ADDENDUM No. 1

PROJECT MANAGEMENT - PUBLIC SERVICES - CITY OF ANN ARBOR  
GEDES AVENUE IMPROVEMENTS  
PROJECT DETAILS  
INFILTRATION DETAILS

PROJECT MANAGEMENT - PUBLIC SERVICES - CITY OF ANN ARBOR  
GEDDES AVENUE IMPROVEMENTS  
GEDDES AVENUE TYPICAL SECTIONS  
P.O.B. TO 23+75

PROJECT MANAGEMENT - PUBLIC SERVICES - CITY OF ANN ARBOR  
GEDDES AVENUE IMPROVEMENTS  
STORM SEWER PLAN AND PROFILE  
STA. 29+50 TO STA. 33+50

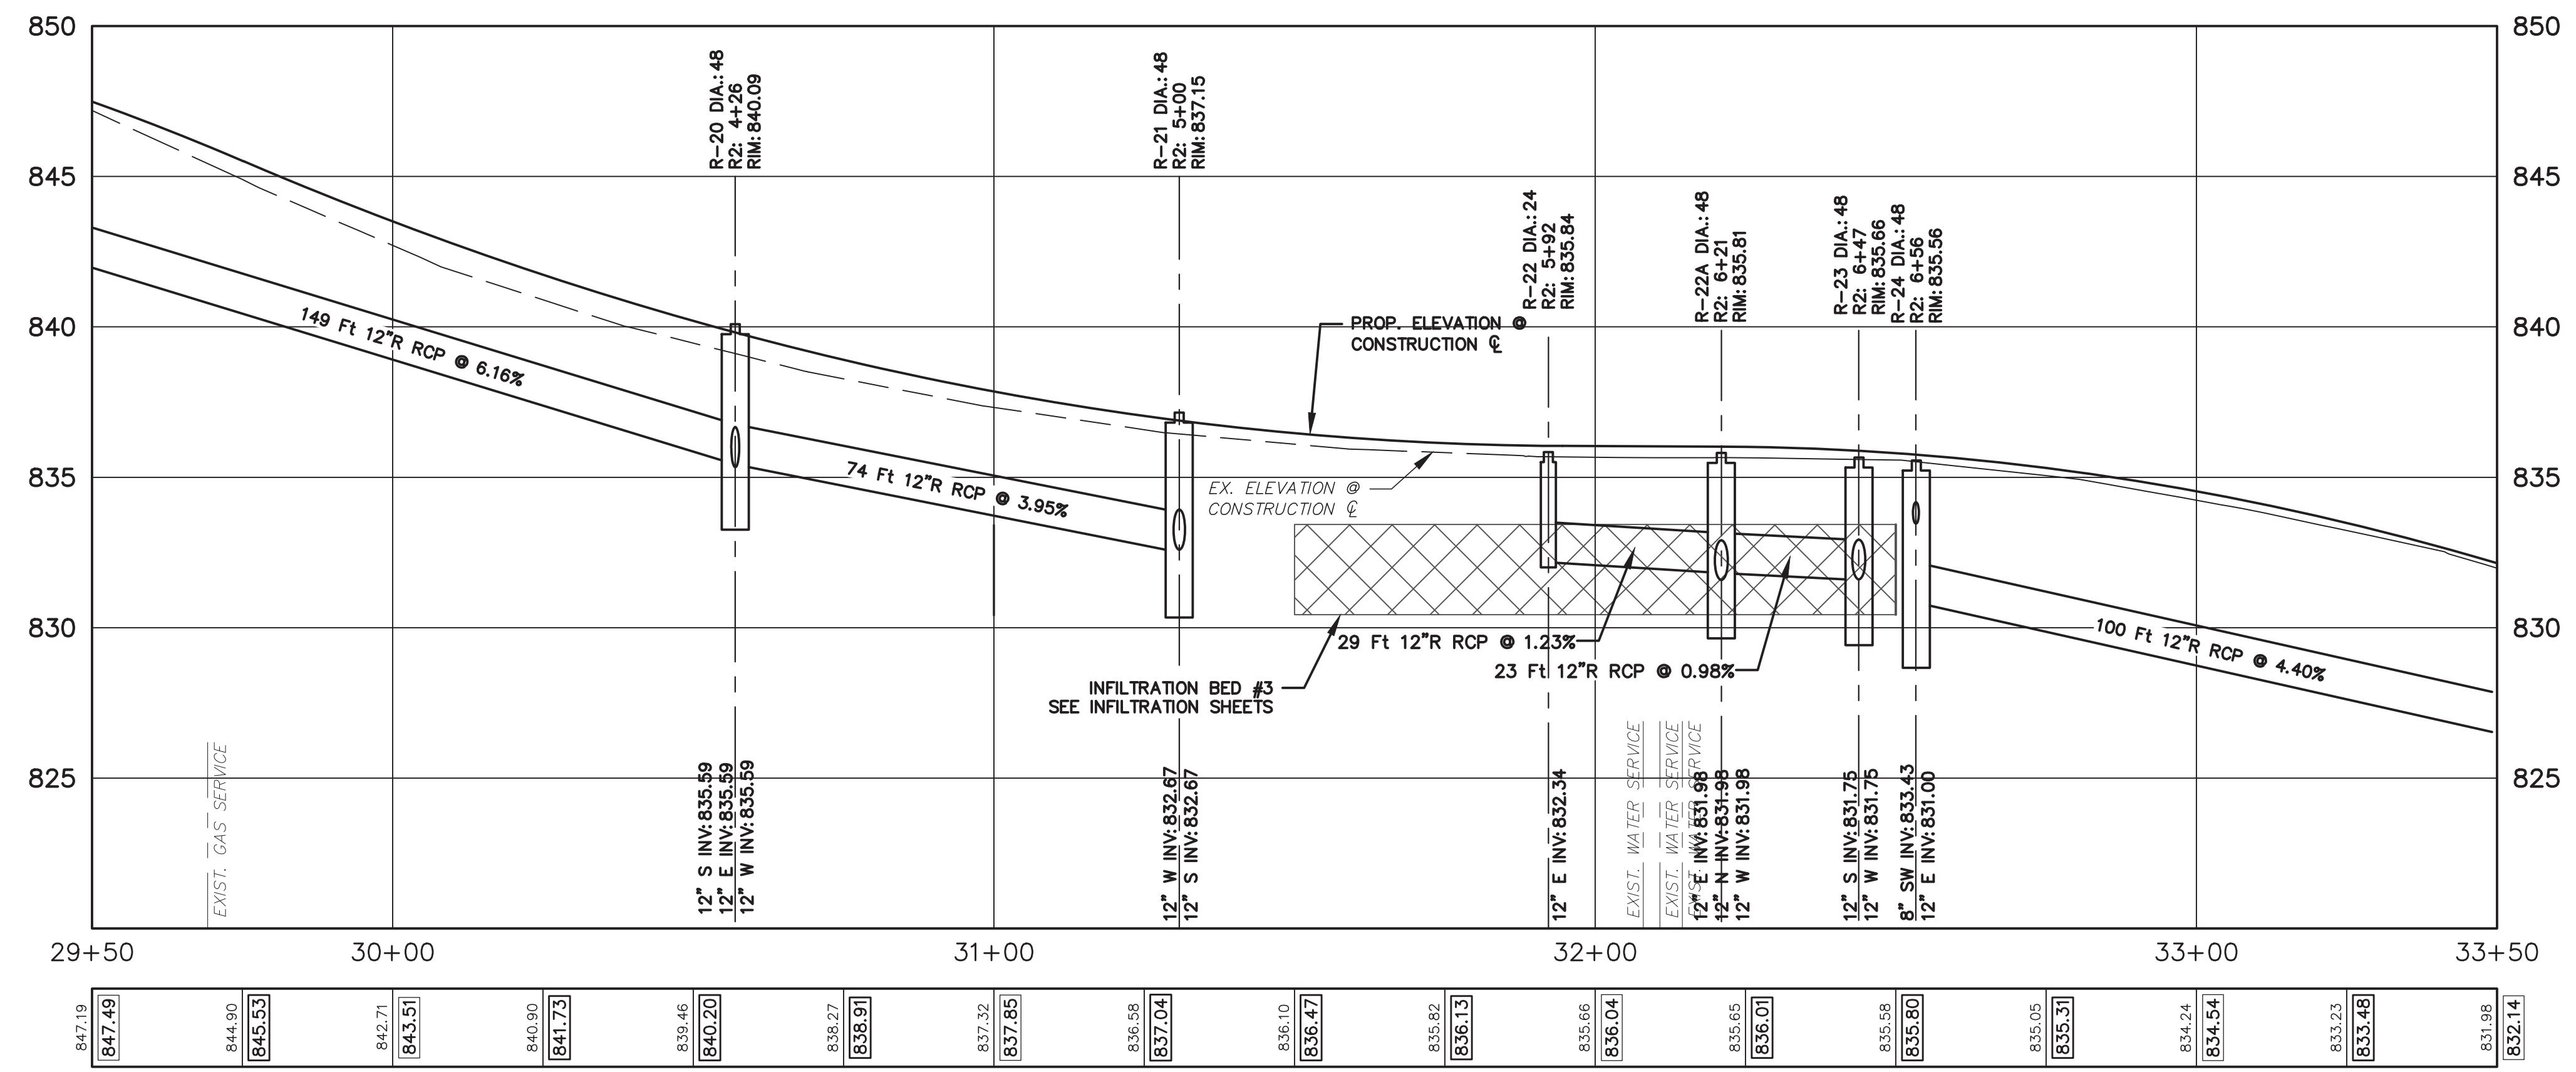
ALL DEPTH INFORMATION HAS BEEN UPDATED IN THE STORM SEWER STRUCTURE TABLE. STRUCTURES NOT REQUIRING A SUMP HAVE BEEN IDENTIFIED.

PROJECT MANAGEMENT - PUBLIC SERVICES - CITY OF ANN ARBOR  
GEDDES AVENUE IMPROVEMENTS  
STORM SEWER PLAN AND PROFILE  
STA. 33+50 TO STA. 37+50

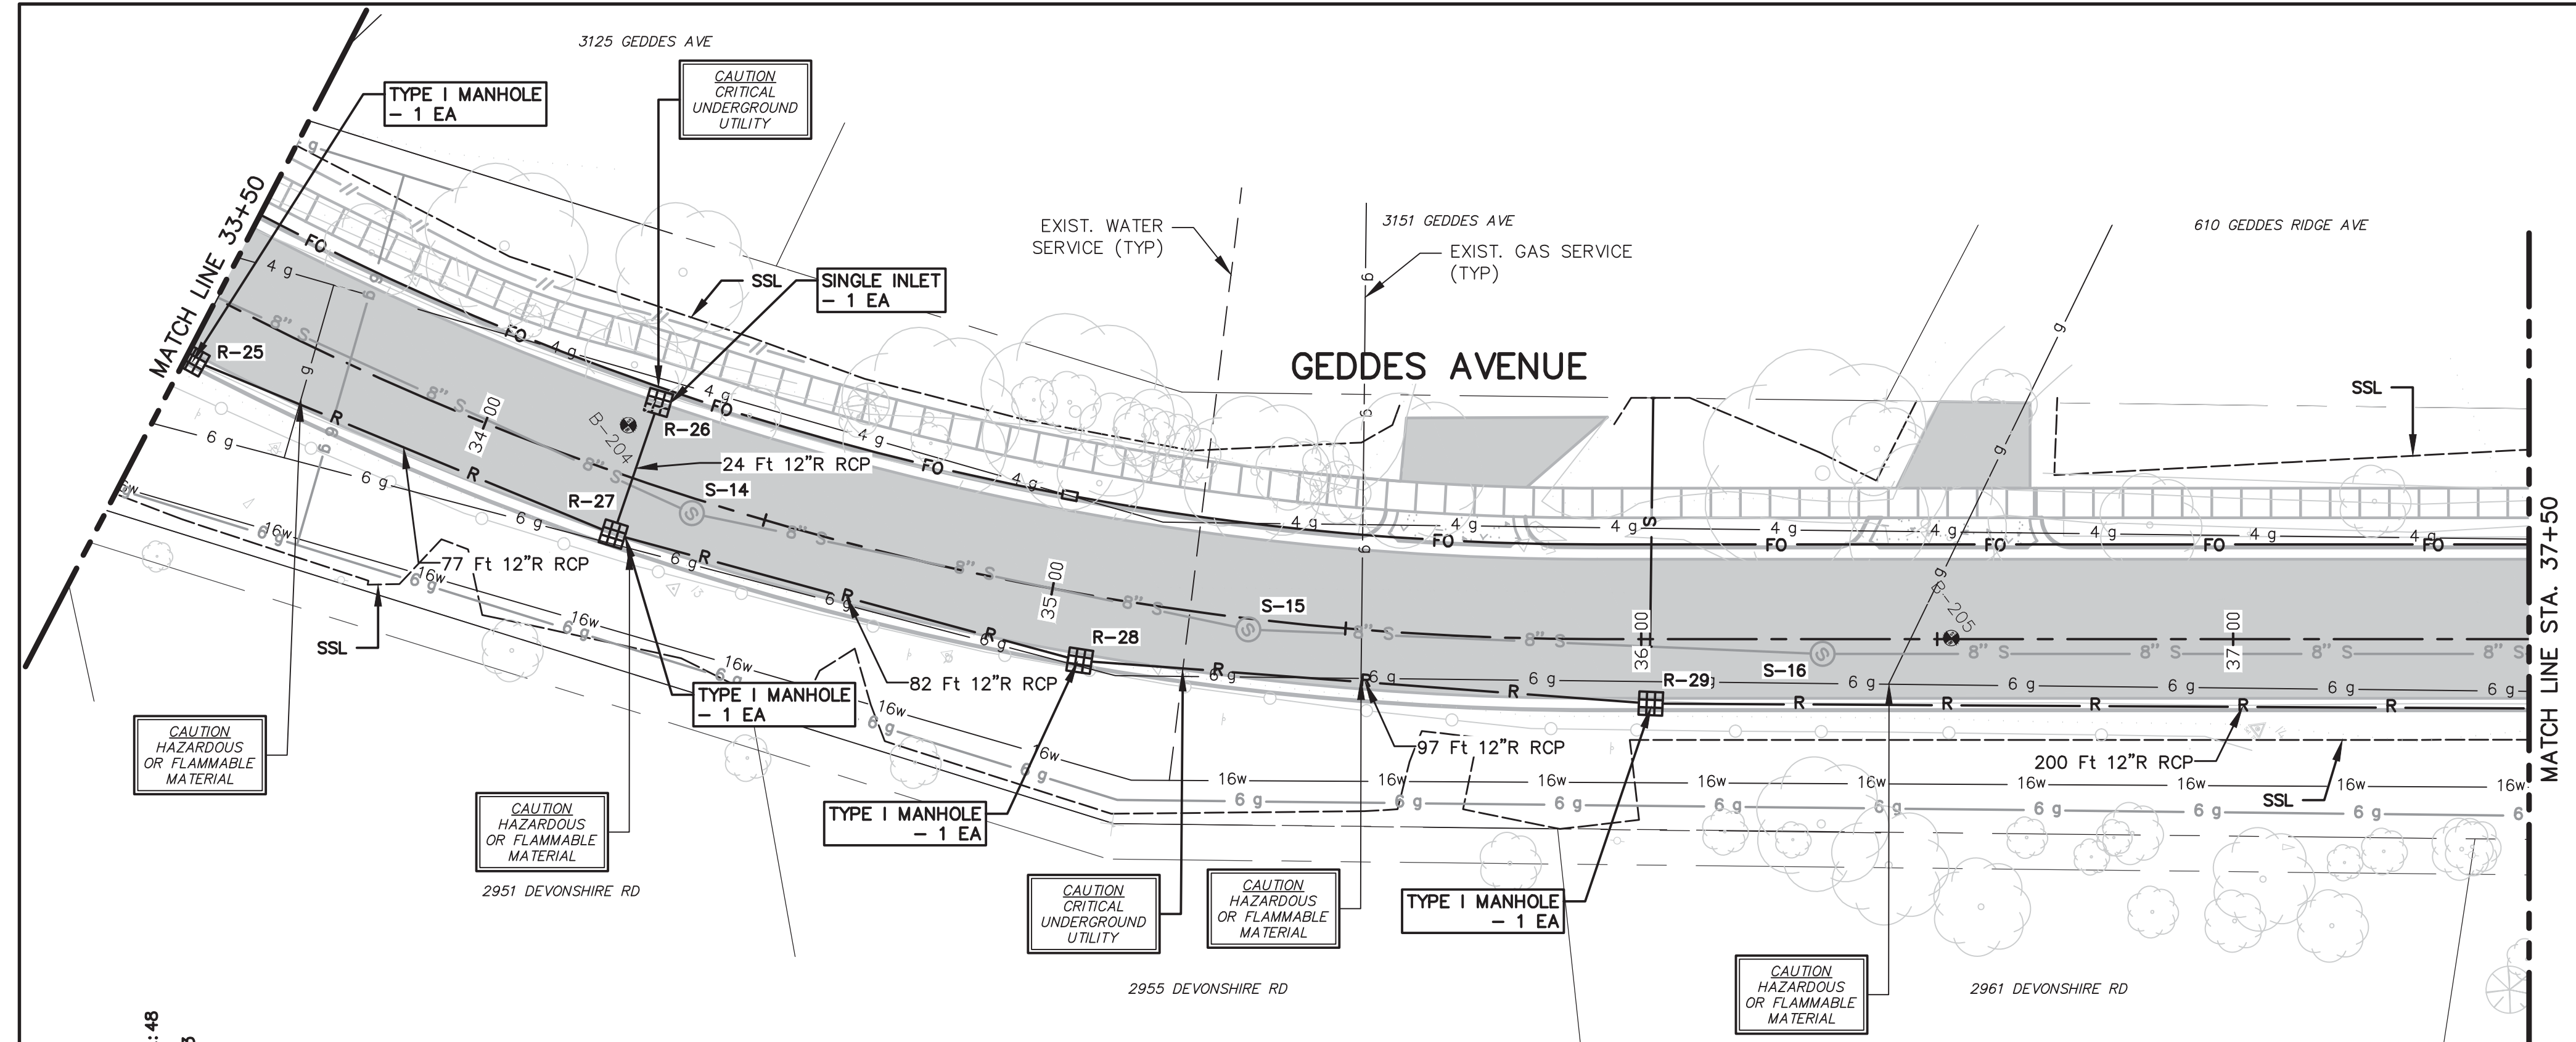
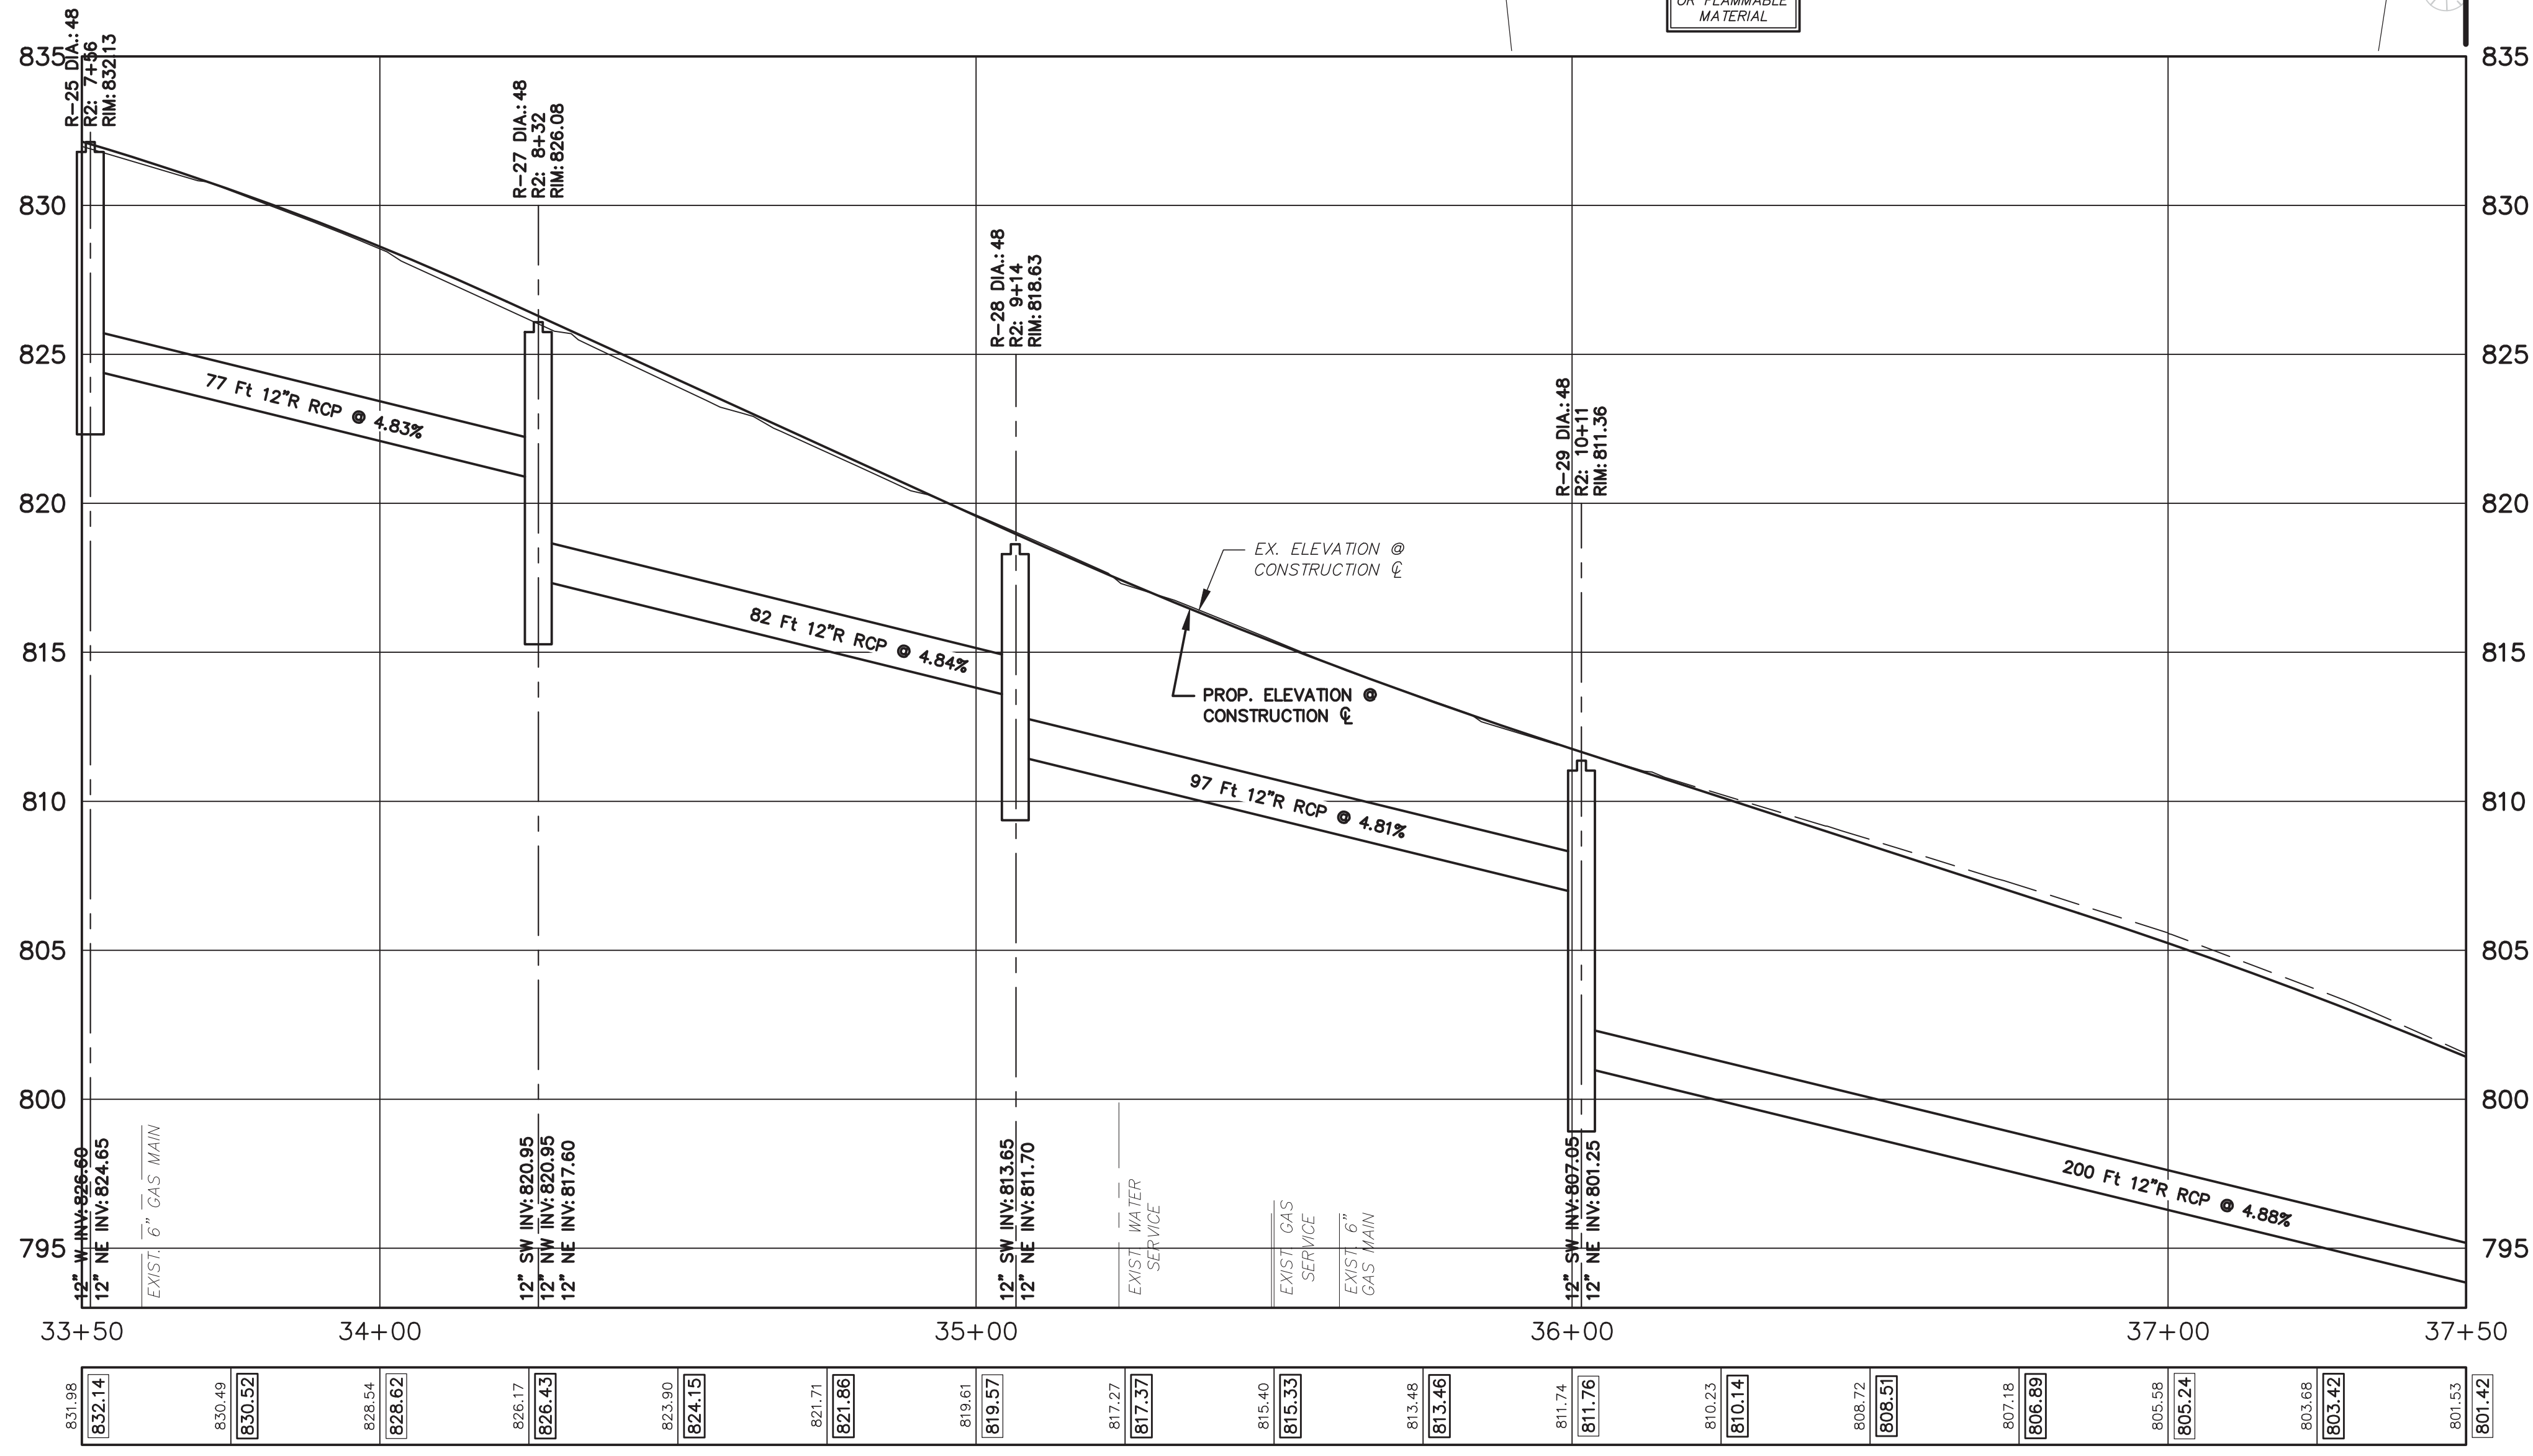
ALL DEPTH INFORMATION HAS BEEN UPDATED IN THE STORM SEWER STRUCTURE TABLE.
